TM Art Can *Damage* Wrecker's Boom Winch

YOUR M1089A1 FMTV'S UNDERLIFT ASSEMBLY OPERATION IN TM 9-2320-392-10-1 IS AN EXAMPLE.

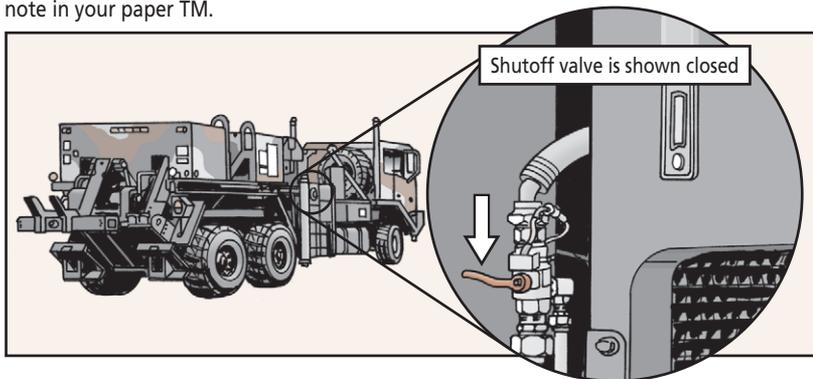
The artwork for the Underlift Assembly Operation in WP 0037 00-01 of TM 9-2320-392-10-1 (Mar 09) and IETM 9-2320-391-10-1/2 (Mar 09) is incorrect. The shutoff valve is shown in the closed position but the callout says the valve is in the open position.

The written instructions for this task correctly state that the valve must be in the open position. However, because the artwork is wrong, some users have mistakenly placed the valve in the closed position, damaging the boom winch.

So disregard the artwork showing the position of the shutoff valve for this procedure. The valve is open when the handle is straight down *in line* with the valve, *not* at a right angle. Make sure the valve is in the open position when performing this task. And make a note in your paper TM.

The valve should only be closed for maintenance purposes. Secure the valve in the open position using a zip tie, such as NSN 5975-01-034-5871. Any zip tie will do, and you should be able to find them in your motor pool.
